SERVICE BULLETIN

Model: Elise

Number:
1999/03

TITLE: Exhaust downpipe steady bracket.

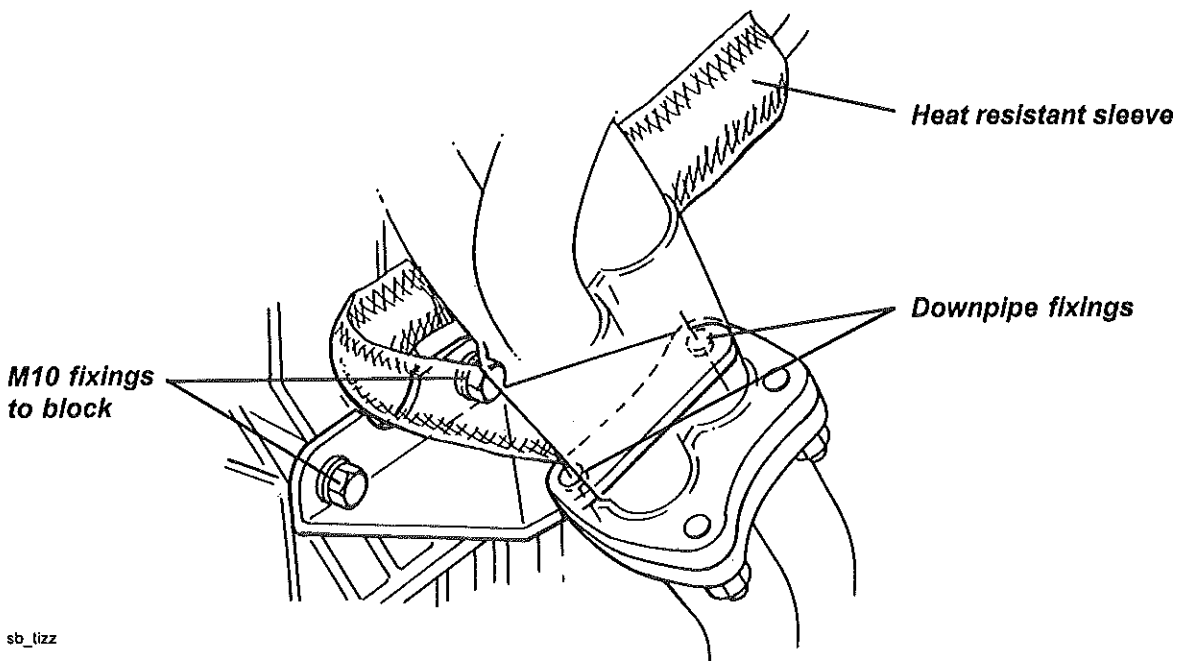
REASON: To prevent exhaust 'tizz' exhibited by very few cars.

ACTION: If an Elise should exhibit a high frequency 'tizzing' noise/vibration originating from the exhaust downpipe, and most prominent at around 2,500 rpm, especially on the overrun, an exhaust manifold/downpipe steady bracket is now available and should be fitted in preference to replacing the downpipe.

Steady Bracket Kit, exhaust manifold/downpipe A111E6234S 1off

1. Remove the engine bay undertray.
2. Remove the two exhaust manifold to downpipe fixing nuts nearest to the block, and fit the new bracket over the studs. Secure the bracket to the two bosses in the block using the two M10 flange bolts supplied.
3. Fit the two M10 flange nuts to the manifold studs, and tighten to 55 Nm.
4. Tighten the two M10 bolts securing the bracket to the block to 55 Nm.
5. Unplug the oxygen sensor harness at the connector clipped to the water rail at the left hand end of the engine, and slide the heat resistant sleeve provided in the kit, onto the cable and over the sensor. Reconnect the harness.
6. Refit the engine bay undertray.
